3 June 2016

Objection to the planning application of Proposed Wetland Restoration Area [("Wetland Habitat" use with excavation (re-profiling of fish ponds)] cum Low Density Residential Development ("House" use with filling of land) near Yau Mei San Tsuen, Yuen Long (A/YL-MP/247)

11 March 2016

Objection to the planning application of Proposed Wetland Restoration Area [“Wetland Habitat” use with excavation (re-profiling of fish ponds)] cum Low Density Residential Development [“House” use with filling of land] near Yau Mei San Tsuen, Yuen Long (A/YL-MP/247)

Figure 1. The Master Layout Plan of the proposed development overlaid with the location of the flight lines identified in the flight line survey.

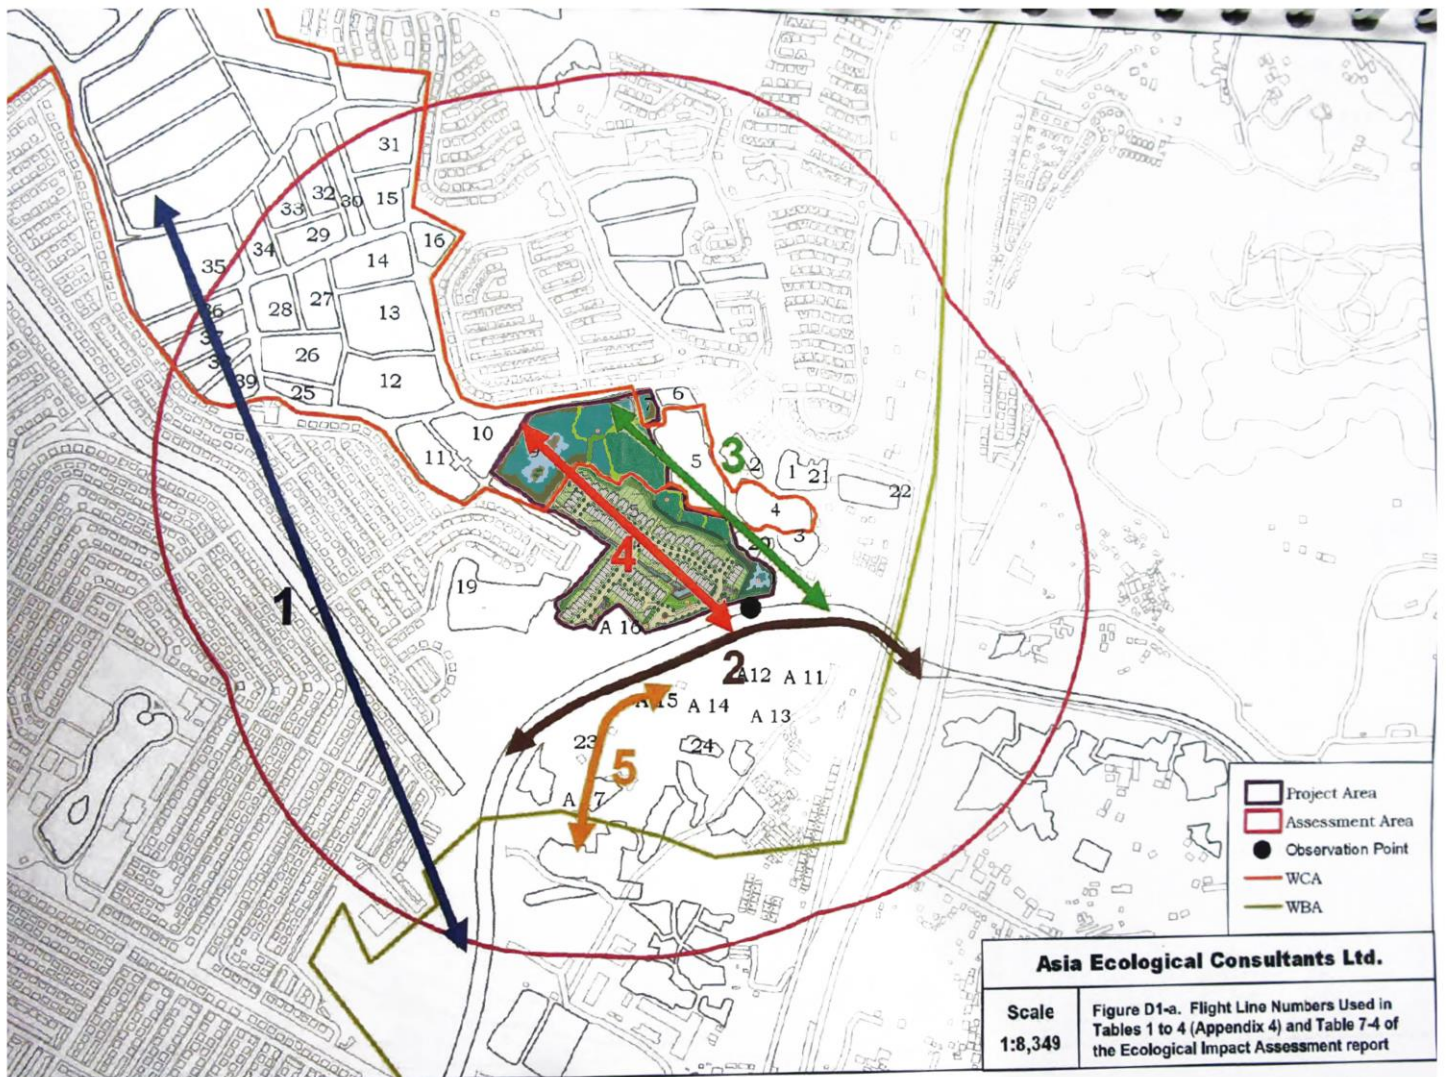
We would like to reiterate that flight lines 3 and 4 are at/close to the application site and they account for 40.1% of the total birds observed¹ (Figure 1). However, we consider that the width of the proposed ecological corridor is inadequate to maintain the ecological connectivity, particular for the movement of waterbirds and wetland dependent birds, between the Ngau Tam Mei Drainage Channel and the Deep Bay wetland system. Maintaining such ecological connection is a requirement listed in the Environment Permit No. EP-500/2015 granted for the proposed development, and should be strictly followed.

Figure 1. The location of the flight lines identified in the flight line survey

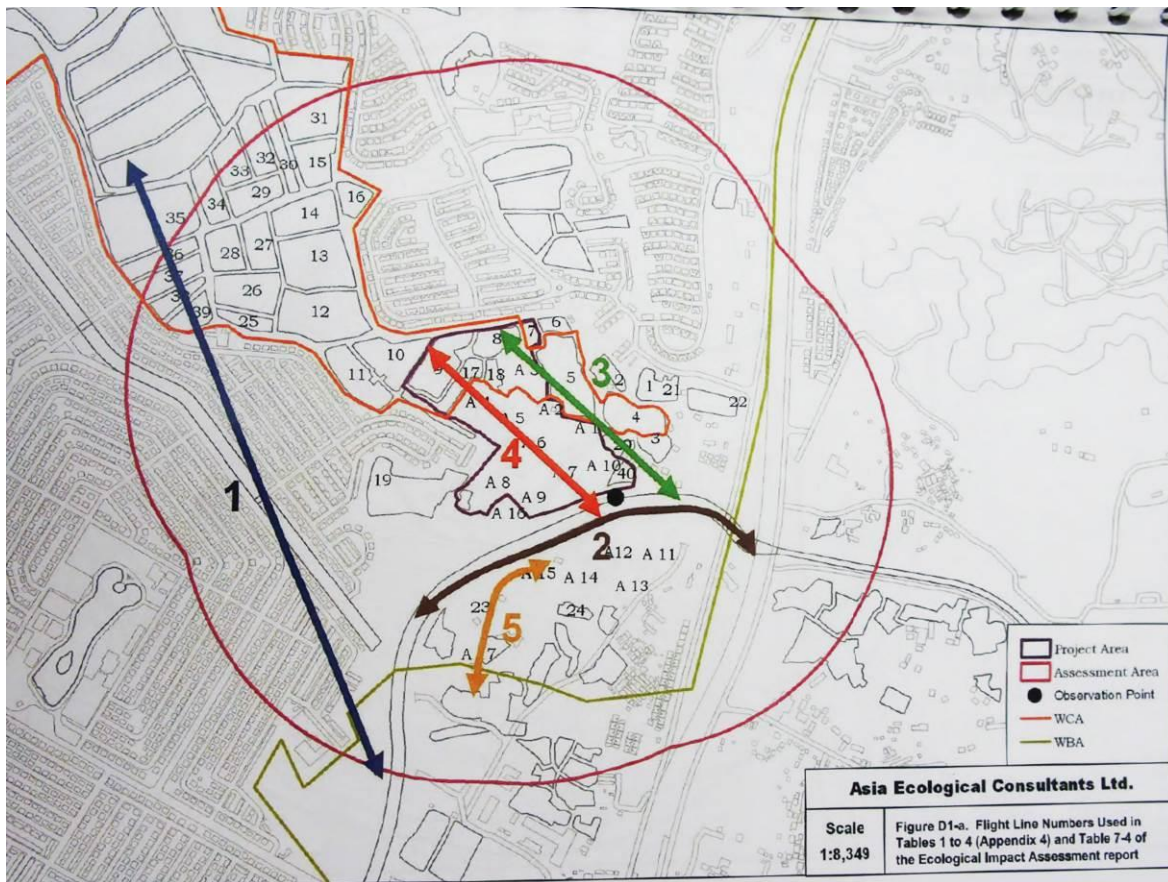
From the findings of the flight line survey (Figure 1), flight lines 3 and 4 are at/close to the application site and they account for 40.1% of the total birds observed¹. These findings indicate that the ecological corridor, which is located between the Ngau Tam Mei Drainage Channel (NTMDC) and the wider Deep Bay area via the application site and its immediate surroundings, is significant for waterbirds and wetland-dependent birds. Currently, the Project Site and its immediate surroundings consist of dry agricultural fields, grassland, shrubland and ponds. They form a continual natural vegetated area which provides an ecological corridor for the movement of birds and other wildlife.

Figure 2. The proposed layout of Wetland Restoration Plan (Figure 8 of the Ecola)

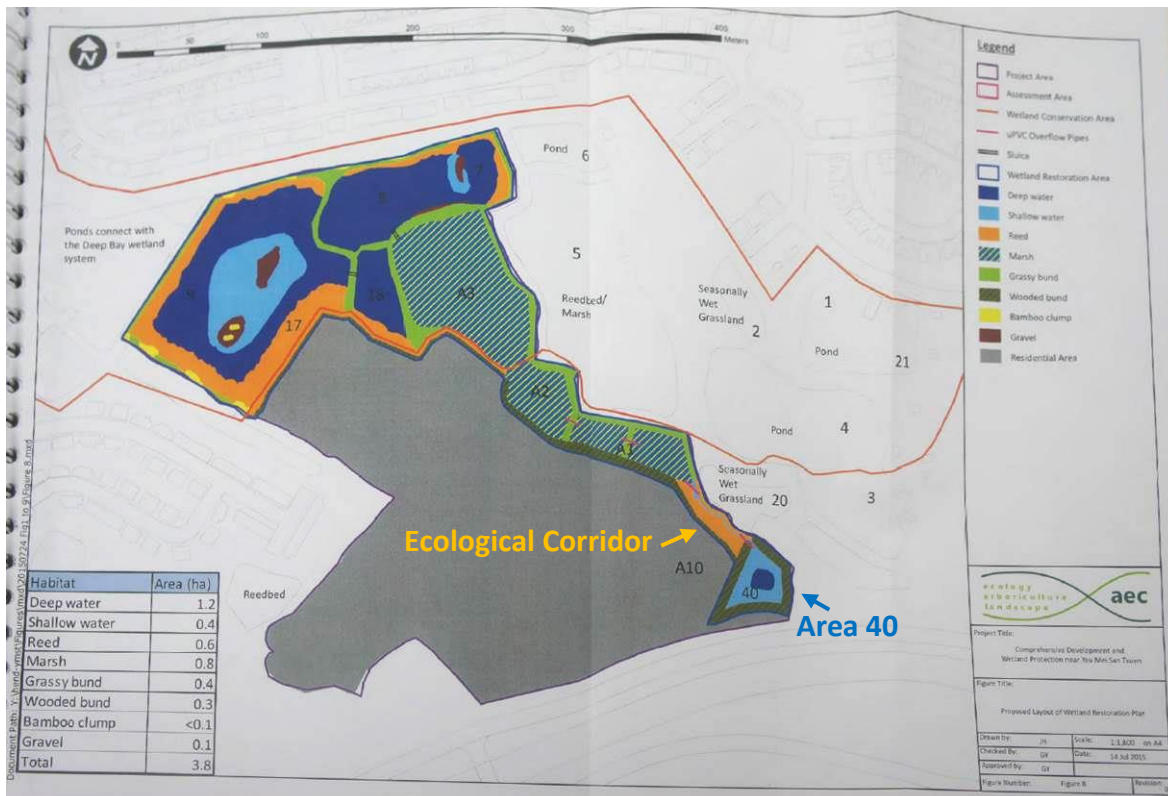
From the proposed layout of Wetland Restoration Plan, Area 40 would have shallow and deep water habitats, which are likely to attract large waterbirds for foraging and roosting (Figure 2). The area may also act as a stepping stone for the movement of large waterbirds between the NTMDC and the Deep Bay Area. As the proposed ecological corridor is immediate adjacent to Area 40, we consider that large waterbirds would utilize the ecological corridor, particularly for those which use Area 40 as a stepping stone for their flight between Deep Bay and the NTMDC. We reckon that both the width of the ecological corridor and the height of built-up structures would affect the taking off/landing of birds and their flight lines.
